Minta Farm
Amendment C269
Expert Evidence – Traffic & Transport

190315PAN001C-F

3 April 2020

Figure 5 Design Comparison

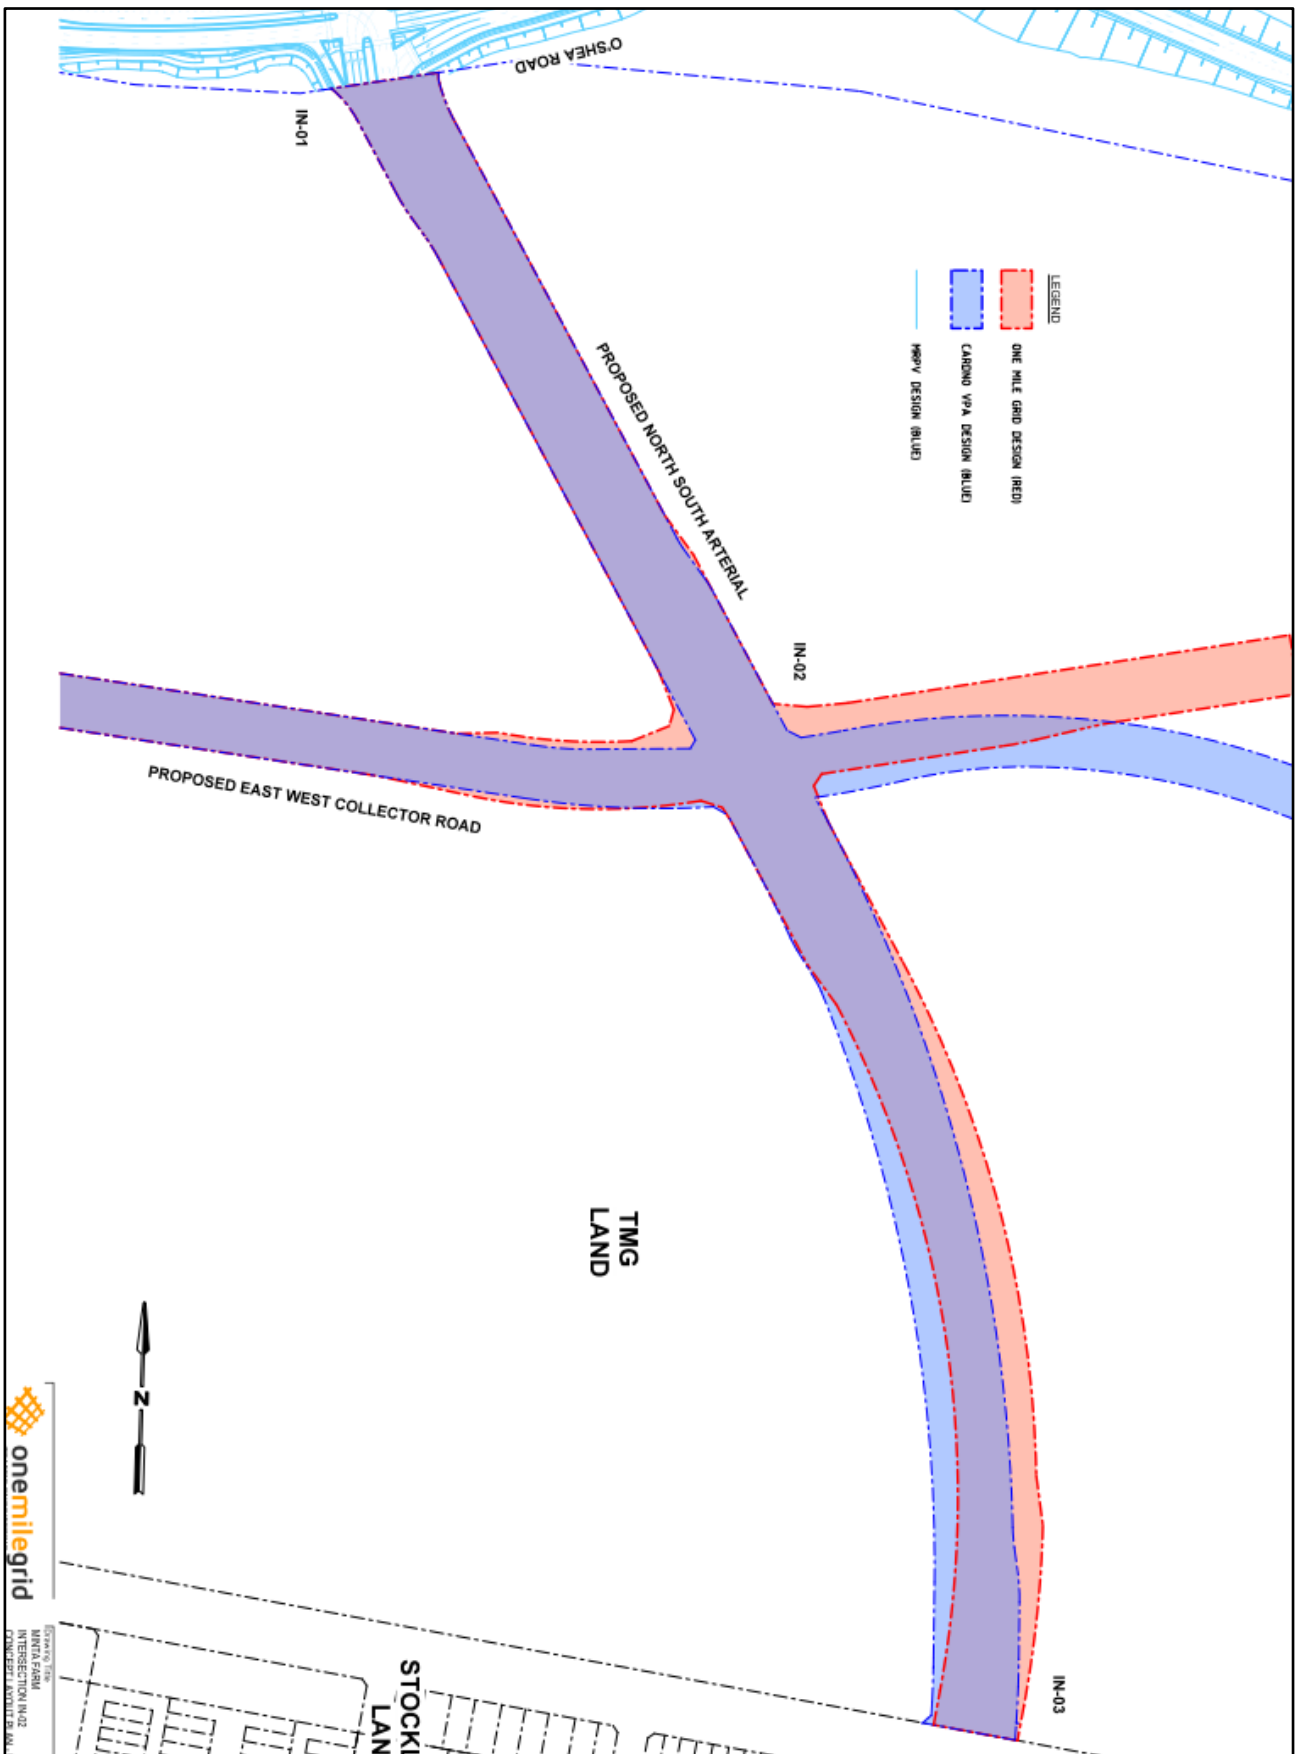
Within TMG's land parcel, the alignment of the future road effectively holds intersection IN-03 in the south and IN-01 in the north with a constant radius applied. From a high level, I have no concern with this alignment as a general principal for the main road however I do note that the alignment does result in skewed intersections at IN-03 and IN-02. The skewed nature has resulted in angled approaches to the intersection which, where they can be avoided, should as a matter of best practice and good transport planning.

In this regard, my firm undertook a design exercise to review the intersection arrangements for IN-03 and IN-02 to provide for a more conventional intersection configuration. Whilst the angled approaches cannot be completely removed, the design prepared by my firm in my view improves the intersection arrangements. As noted previously, intersections along the length of a road impact on the alignment and as such my review results in a revised alignment for the north – south arterial and a marginal relocation of IN-02. Specifically, the following has resulted:

- IN-02 has shifted approximately 8 metres north to provide a straight alignment through the intersection, rather than a radius within the intersection.
- The north – south arterial road has been realigned between IN-02 and IN-03 to provide a single 550 metre horizontal alignment radius for an 80km/h roadway.

The recommended modifications to the alignment of the north – south arterial and corresponding intersections are provided within the attached functional layout plan, with an extract of which provided in Figure 4 (Green – Cardno design, Black – **onemilegrid**). A shaded comparison diagram to provide for clarity between the two designs is provided in Figure 5 which shows the Cardno design in blue, the **onemilegrid** design in red and overlay area (common) in purple.

In view of the above, it is my view that the alignment of the north – south arterial road and subsequently the PAO should be modified in line with my design which will provide for an improved road alignment and future intersection layout. I note that the current PAO design is not unreasonable and could be implemented however the revised design I have proposed results in improvements which in a green field setting with one land ownership should be considered.

Figure 6 IN-02 – Modified Functional Layout

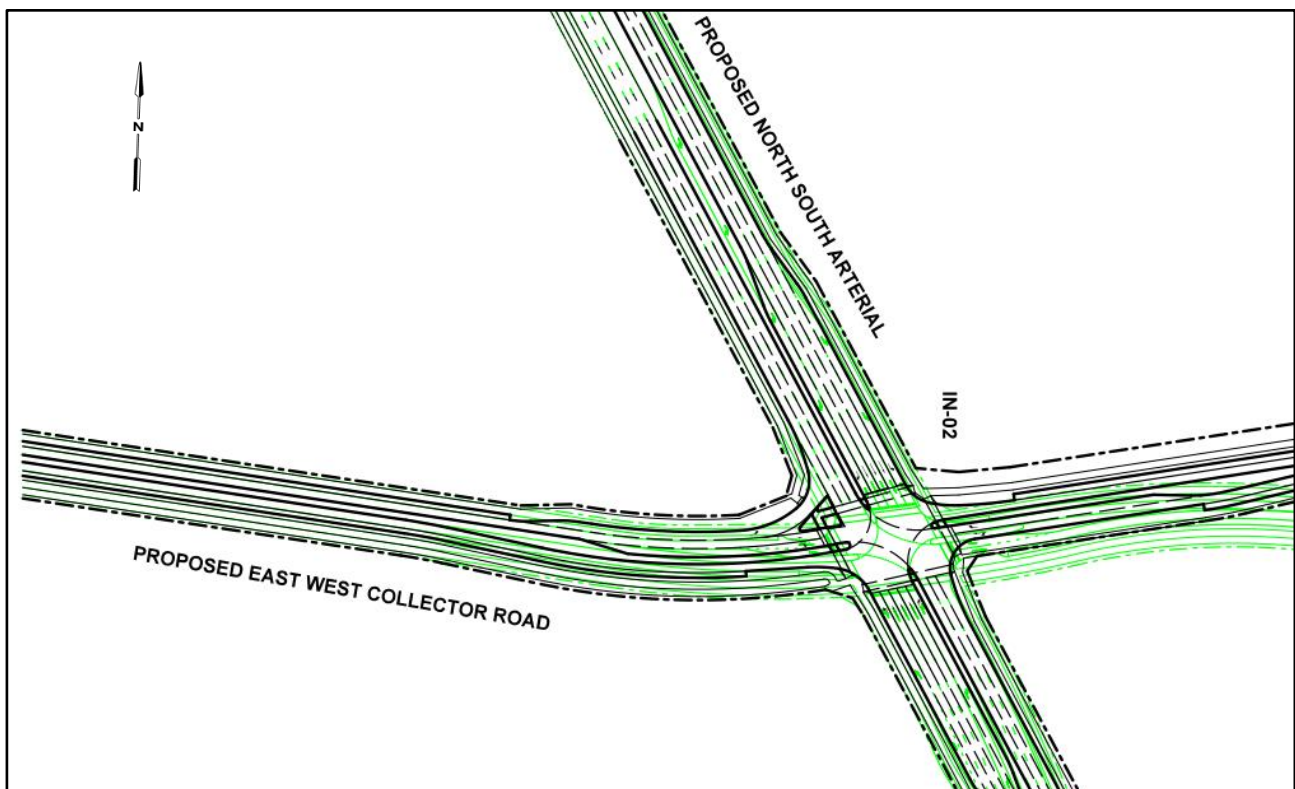
I have recommended modifications to the intersection orientation for IN-02 to provide for a more conventional intersection arrangement. Effectively, my review has removed the radius which was applied through the intersection in both directions and instead provided a straight which allows for improved approaches to the intersection and sightlines.

I note that the PSP design includes a left turn slip lane on the northwest corner of the intersection from the collector road to the arterial. As this intersection is located within a local town centre and commercial precinct, typical practice to promote pedestrian safety is not to provide slip lanes due to the potential vehicular / pedestrian conflicts. The slip lane should therefore be removed.

An extract of the proposed modifications to the intersection arrangements for IN-02 is shown in Figure 6 (Green – Cardno design, Black – **onemilegrid**), with the full design provided in Appendix A. A shaded comparison diagram to provide for clarity between the two designs is provided in Figure 7 which shows the Cardno design in blue, the **onemilegrid** design in red and overlay area (common) in purple at the intersection.

Figure 7 Design Comparison at IN-02

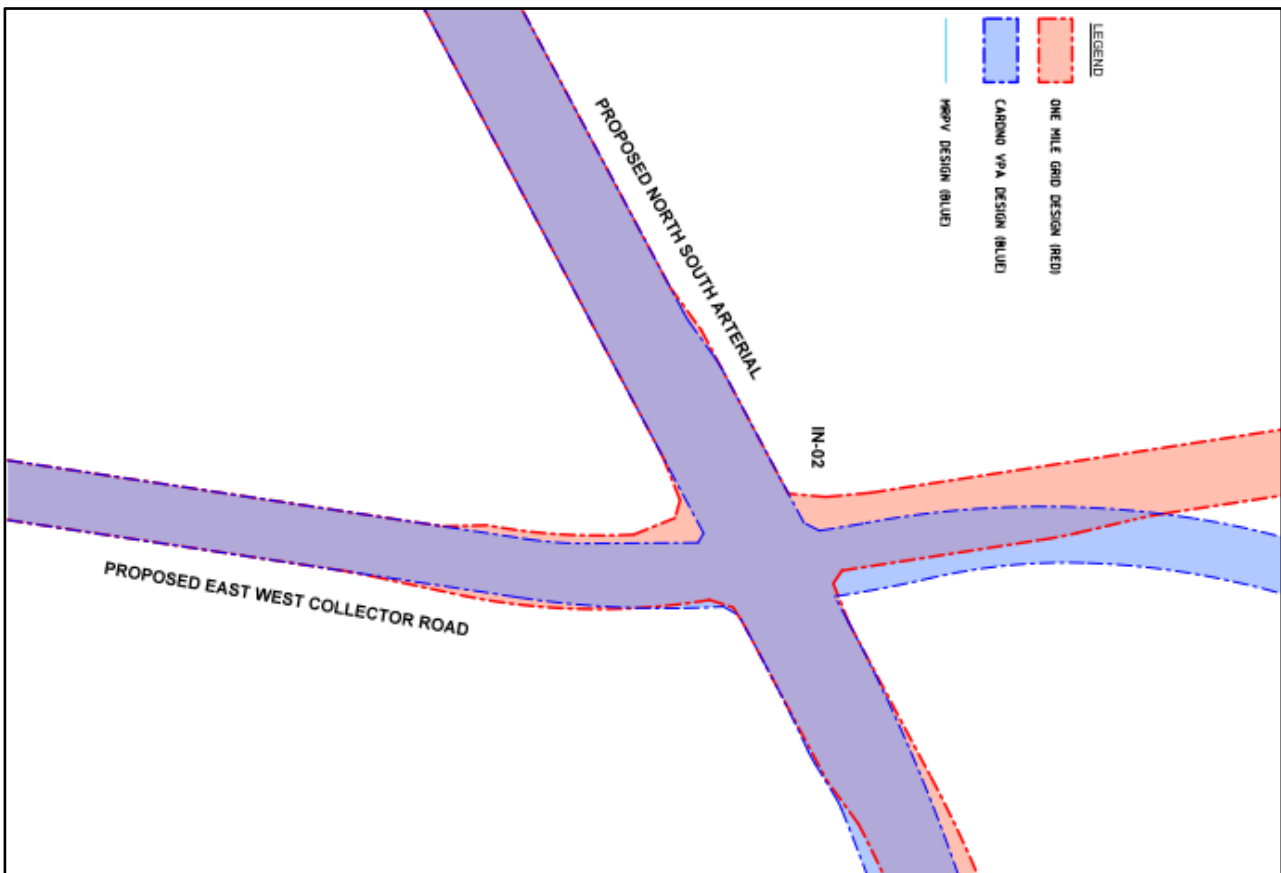
As noted, there is no change to the functionality of the intersection.

Figure 8 Recommended IN-03

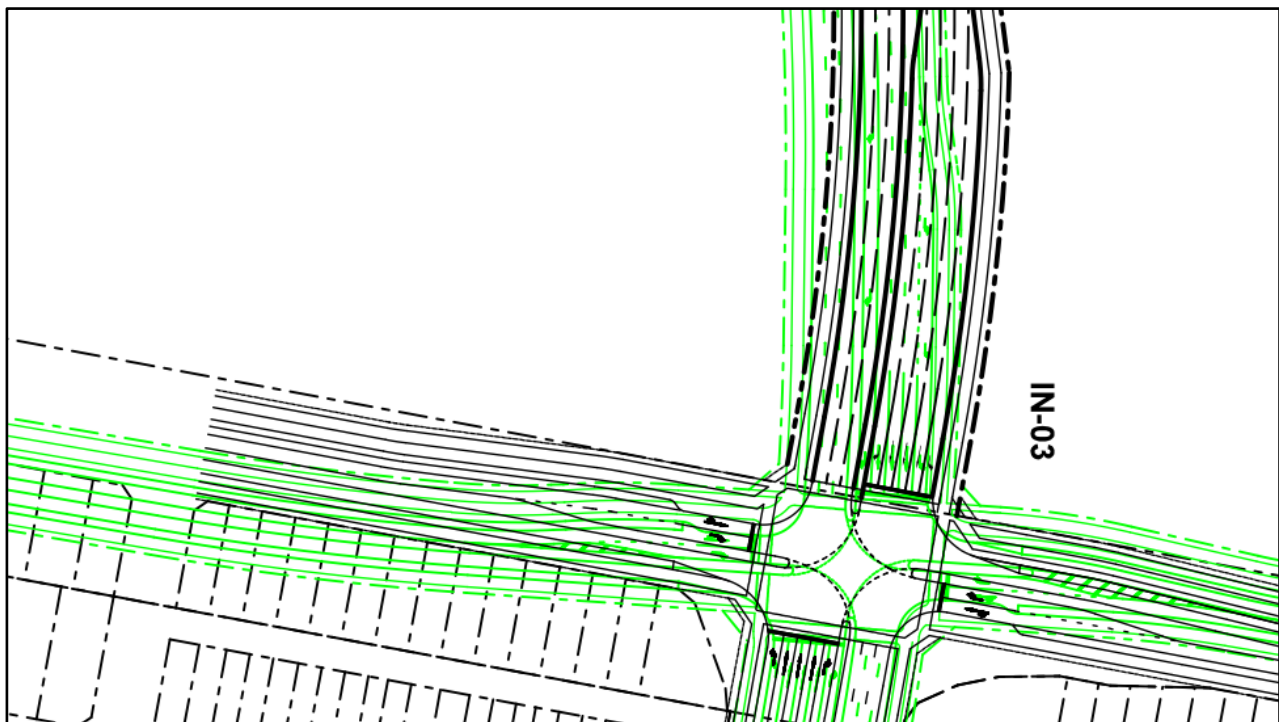
Ratio were engaged by Stockland to undertake a similar intersection review within the Stockland land parcel. My design review has held the Ratio intersection configuration at the land boundary with minor adjustments to the northern leg of the intersection to facilitate the modifications to the alignment of the north – south arterial.

An extract of the proposed modifications to the intersection arrangements for IN-03 are provided in Figure 8 (Green – Cardno design, Black – **onemilegrid**), with the full design provided in Appendix A.
